PERSIMMONS

SP-2018-0579C.SH

VARIANCE REQUEST

FINDINGS OF FACT (LDC 25-8-41)

PROPOSED SITE PLAN

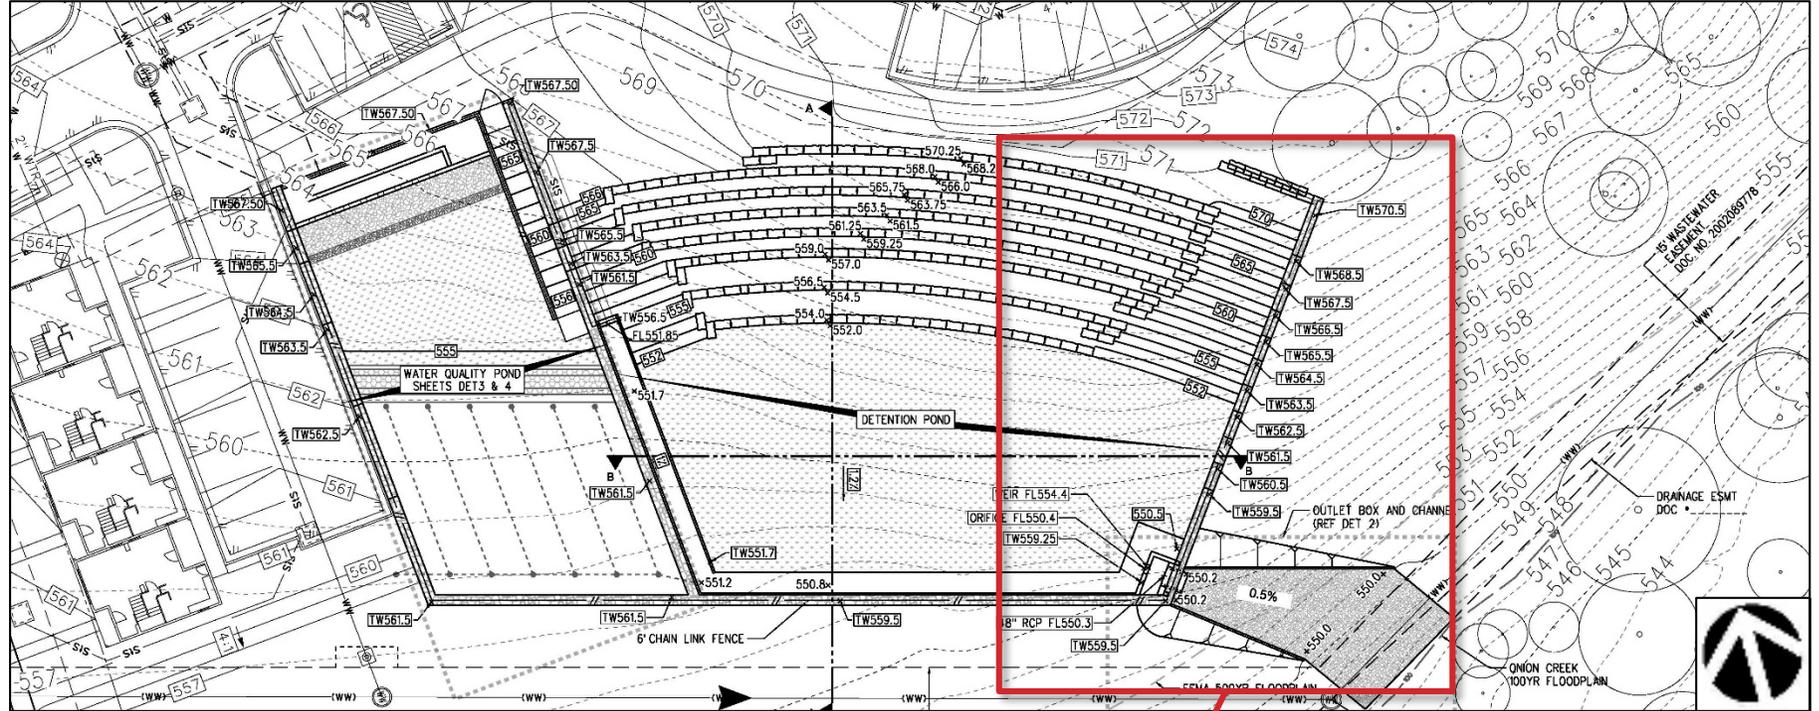
- 2. To allow cut over four feet on slopes in excess of 15 percent
[LDC 25-8-341]**

Area of site plan
requesting variance

- **Staff has determined the required Findings of Fact have been met, and recommends approval of the variance request with the following conditions:**
 - Revegetate the top and backside of the detention pond berm with native, deep-rooted bunch grasses; and,
 - Provide additional tree protection for trees 4-8” in diameter located east of the proposed pond along the steeper slopes.

POND SECTION

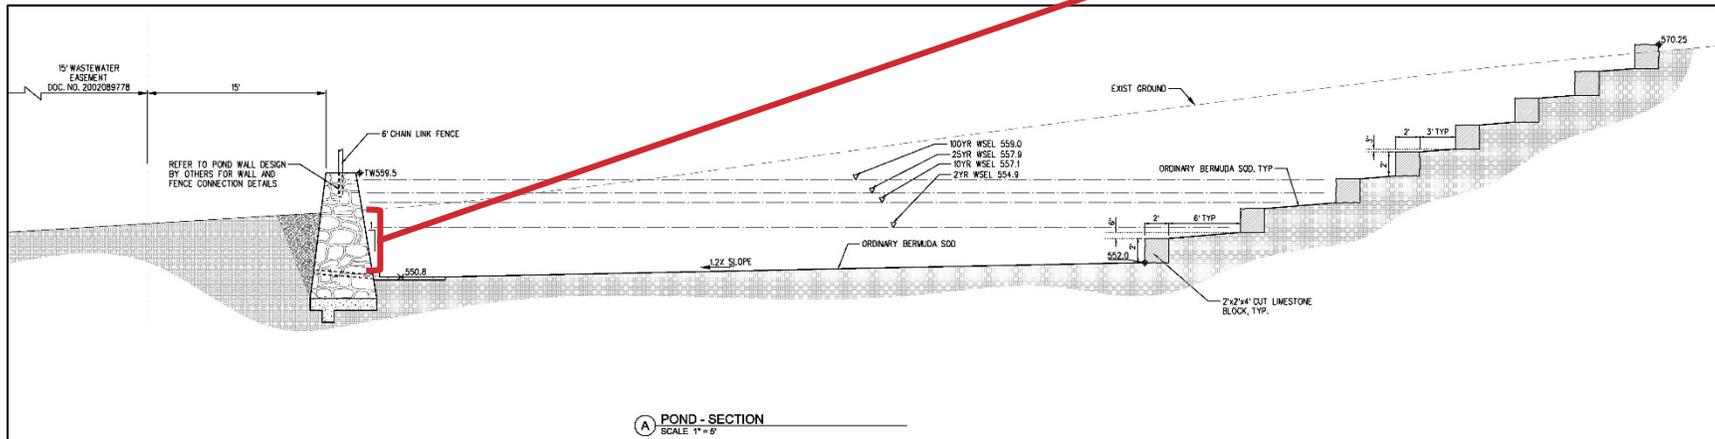
DETENTION POND ENLARGEMENT

Max. 12.5 feet of cut

All cuts will be stable, vertical cuts that will be reinforced with concrete retaining walls to prevent erosion from occurring in the location of the cut. The disturbed areas within the vicinity of the cut will be required to be restored with native, deep-rooted bunch grasses and other forbs indicative of a Blackland Prairie.
